SITE PLAN REVIEW AND APPEARANCE BOARD STAFF REPORT

Pierre Delray II

Meeting	File No.	Application Type
September 28, 2022	2022-080-SPM-SPR-CLIV	Class IV Site Plan
Property Owner		Agent
Pierre Delray Two LLC		Dunay, Miskel, Backman LLP

Waiver #1, Side Interior (West) Setback Reduction

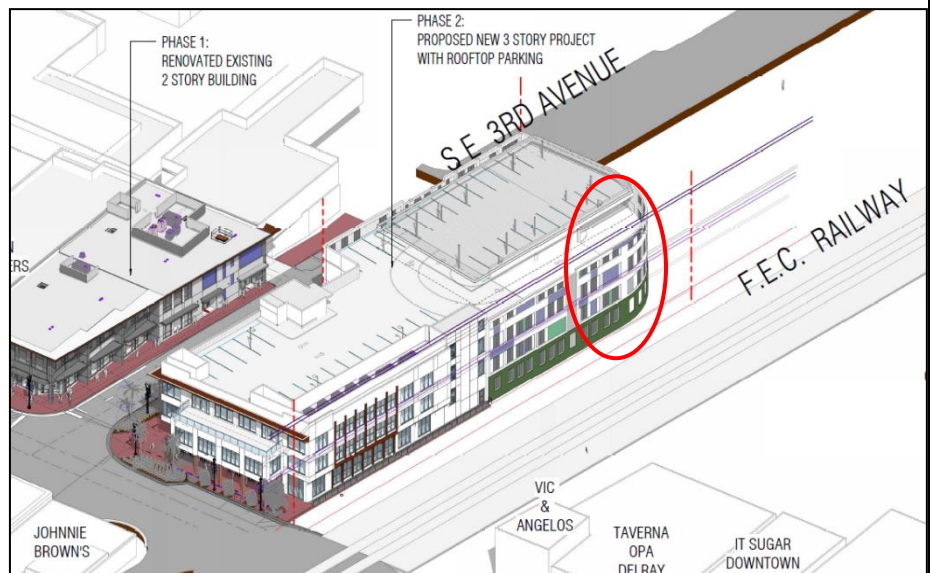
The applicant has requested a side setback of 2 feet, 3 inches from the west interior property line (see area circled in red). This waiver had been previously granted for the initial Class V Site Plan application. However, with the revision proposed per the Class IV Site Plan Modification, the reduced setback will occur within the southern parcel that was not originally included within the scope of work, and as such, the previous waiver approval does not apply to the newly acquired parcel. Therefore, the applicant is requesting the waiver so that the building setback for the portion of the structure that will be located within the southern parcel is consistent with the setback as approved for the portion of the building included within the original parcel to the north.

The impact of the reduction is minimal given that the area to the west of the property is occupied by the FEC railway line. As such, no building will be constructed within the adjacent property to the west and the need for increased clearance between buildings with openings on abutting parcels is therefore not applicable to this site. Further, facades without openings are permitted at a zero-foot setback. The waiver appears to meet the intent of the applicable criteria and is not anticipated to produce any adverse impacts.

Waiver #2, Additional Story above Arcade

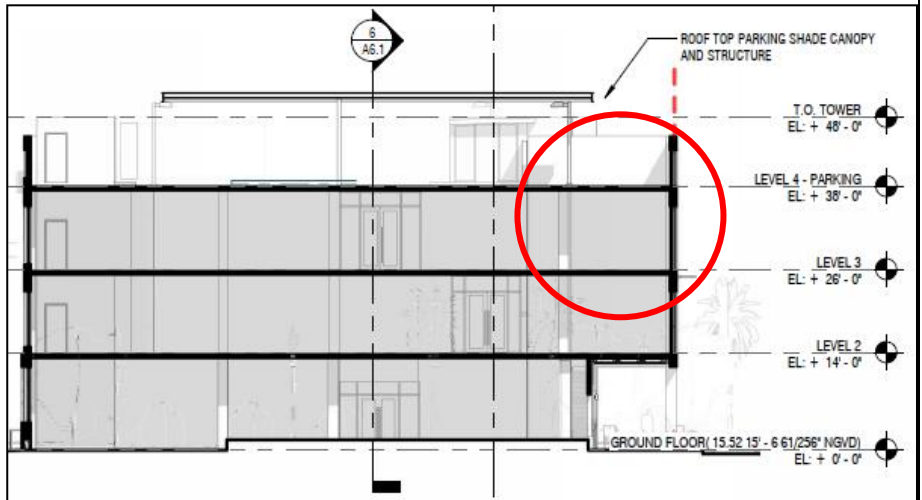
The applicant has requested the ability to extend the arcade beyond the second story to provide an additional (third) story, which extends over the ground floor setback area and encroaches approximately 18 inches into the right-of-way. A similar waiver was previously granted for the arcades associated with the initial Class V Site Plan application. However, with the revision proposed per the Class IV Site Plan modification, the additional story above the arcade along SE 3rd Avenue extends into the parcel to the south. As such, the previously approved waiver does not automatically apply to the additional portion of the development and the request must be reconsidered.

The third-floor addition above the arcade includes portions of the extended parking garage. The inclusion of the usable area on the second floor for both habitable space and parking is permitted by right, however the extension above the second floor to include the third floor requires a waiver. It would not be feasible to provide the requisite internal circulation for a parking structure given the limited lot width dimension without taking advantage of the area that extends over the arcade.

The requisite design criteria per the CBD standards is met, and the provision of the third-floor arcade does not compromise the CBD design guidelines with respect to the pedestrian environment. The applicant is not benefiting from the request by way of increasing the leasable square footage of the building. Instead, the request is intended to help provide needed parking, which is an amenity for future customers and ensures feasible operations. The waiver appears to meet the intent of all applicable criteria and is not anticipated to produce any adverse impacts.
